Designation: **F1800–07 F1800 – 12**

# Standard Test Method Practice for Cyclic Fatigue Testing of Metal Tibial Tray Components of Total Knee Joint Replacements<sup>1</sup>

FIG. 3 Recommended Spacer Drawing

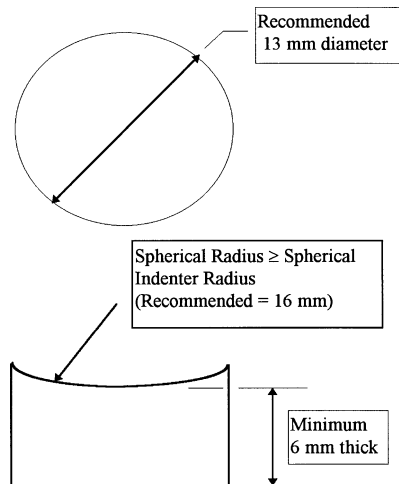
6.4 A spacer of plastic possessing sufficient stiffness and creep resistance (for example, ultra high molecular weight polyethylene, acetal co-polymer) shall be placed between the tibial tray and the load applicator (see Fig. 3). The spacer shall contain a spherical indentation (or recess) for the spherical indenter. This recess shall be greater to or equal than the diameter of the spherical indenter and is included to minimize the chance of spacer fracture under load. The spacer shall have a minimum thickness of 6 mm (0.25 in.); mm, measured at the dome of the sphere. It is recommended that the diameter of the spacer is 13 mm (0.5 in.); mm.
